Notice of Allowability

10/039,638

TU ET AL.

Fig. 3

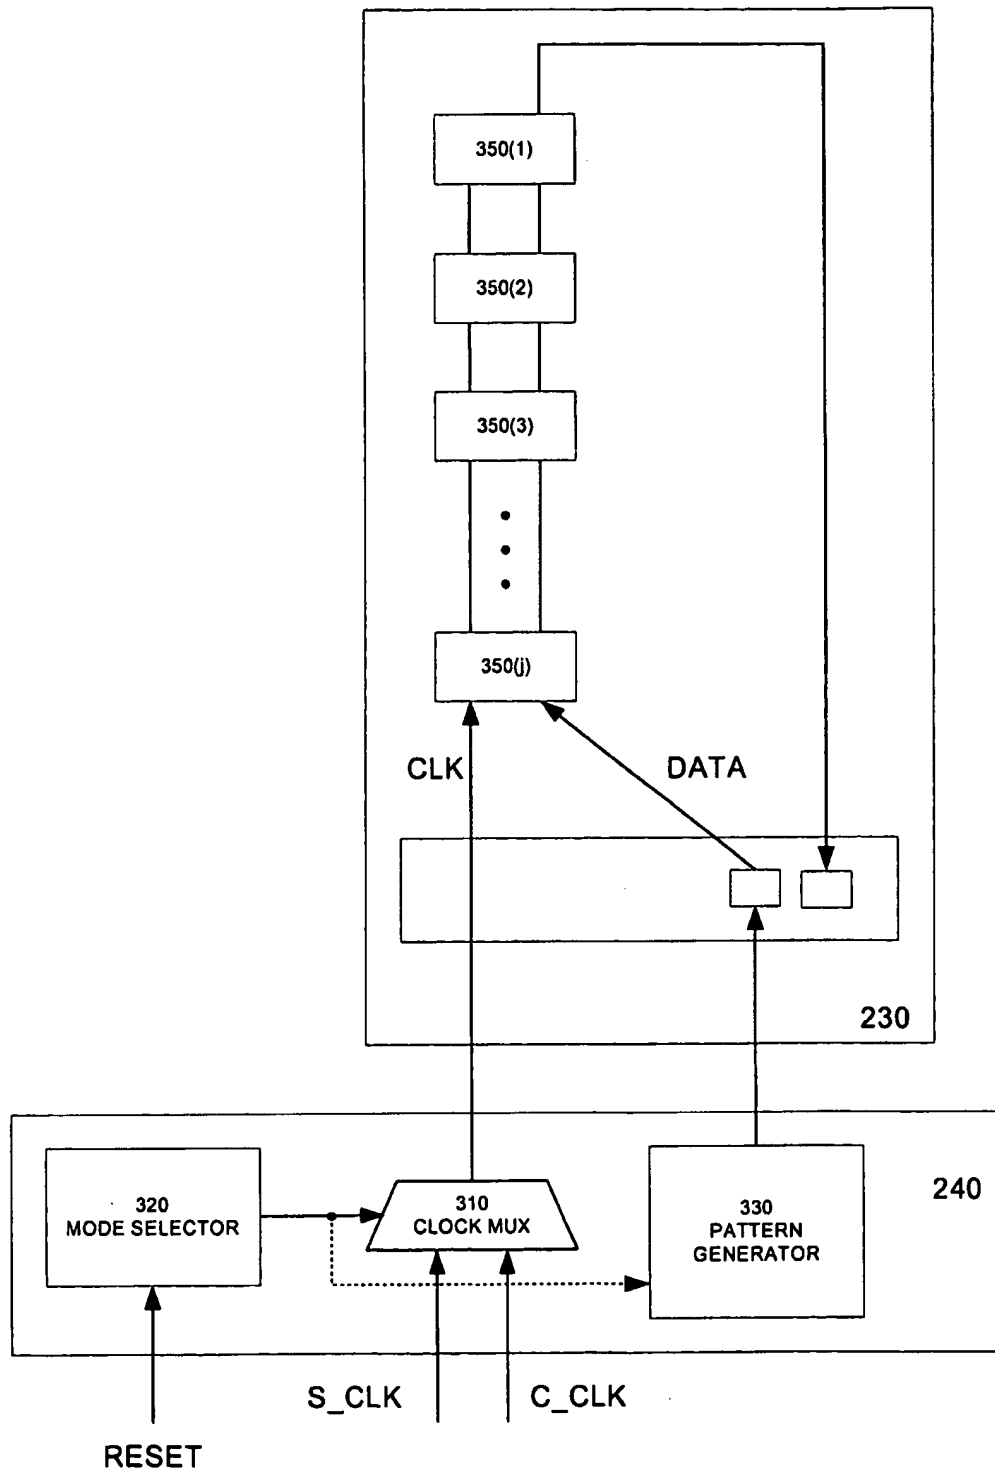
1. In view of the applicant's changes to Figure 3, and Claims 4, 9 and 12, the examiner withdraws all objections to said figure and claims.

The attached drawing sheet contains an amendment to Figure 3. Reference to numbers 330(1)...330(j) has been corrected to read 350(1)...350(j). Applicants submit that no other figure has been amended and no new matter is disclosed.
